UNITED STATES PATENT AND TRADEMARK OFFICE

APPLICATION NO.	FILING DATE	FIRST NAMED INVENTOR	ATTORNEY DOCKET NO.	CONFIRMATION NO.
10/521,725	01/18/2005	Masao Goto	S1459.70058US00	1896

Office Action Summary

**FIG. 1**

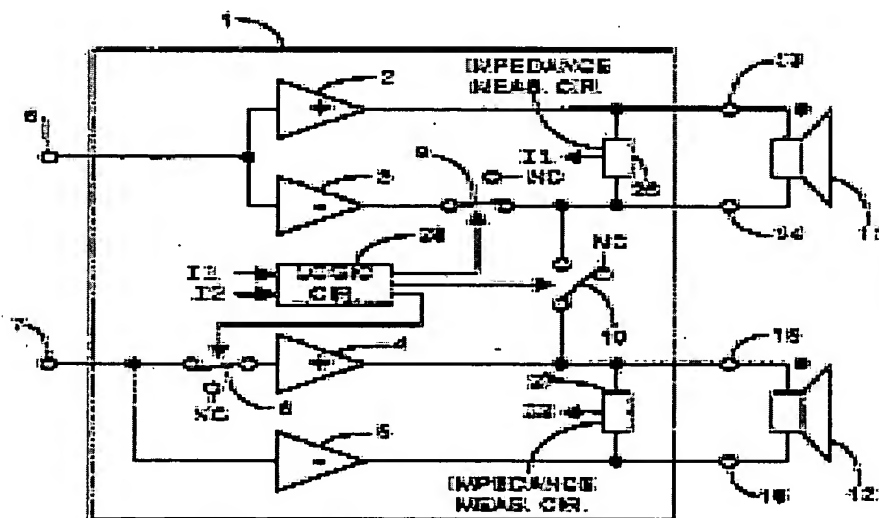
13. Dünnebacke disclose a circuit arrangement for transmitting audio signals. The signal amplifier has an input (6) which is connected to non-inverting amplifier (2) and inverting amplifier (3). Non-inverting amplifier (2) is coupled to speaker load (11) at a node (13) and inverting amplifier (3) is coupled to speaker load (11) at a node (14). Impedance measuring circuit (26) is connected at the outputs of the two amplifiers and processes the impedance of the signal sink (11). A duplicate circuit is set up also. Logic circuit (28) receives the impedance values (I1 and I2) from the measuring circuits (26 and 27) and controls switches (8 and 9), disconnecting or connecting amplifier (3 and 4) from the load and thus configuring the amplifier arrangement from a single end to a bridge mode. See figure 1 and corresponding text.
